COMPREHENSIVE PLANNING COMMITTEE MEETING

January 7, 2026

**Re: Atlas Industrial Data Center – Land Use of Regional Significance
South Whitehall Township
Lehigh County**

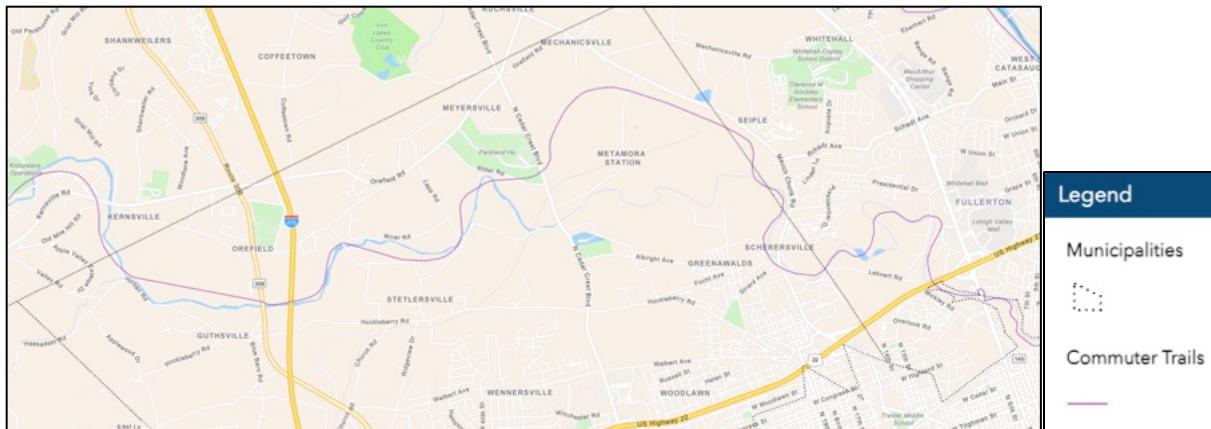
A new township roadway is proposed to be constructed in concurrence with the proposed data center connecting Cedar Crest Boulevard opposite the Parkland High-School driveway and to Mauch Chunk Road just south of the existing Mechanicsville Road Intersection. The LVPC recommends coordination with the school district to minimize potential traffic interactions between students, guardians, and school buses and the traffic generated from the site.

Aspects of the site plan can be improved to better ensure adequate transportation access and movement. There appears to be substantially more passenger vehicle parking spaces than typically required for data center land uses. The amount of provided parking should be re-evaluated and right-sized to minimize impervious surfaces (of Policy 2.2). Once the appropriate amount of passenger vehicle and commercial truck parking spaces is determined, any resulting changes to the site plans should clearly separate these traffic movements to minimize conflicts.
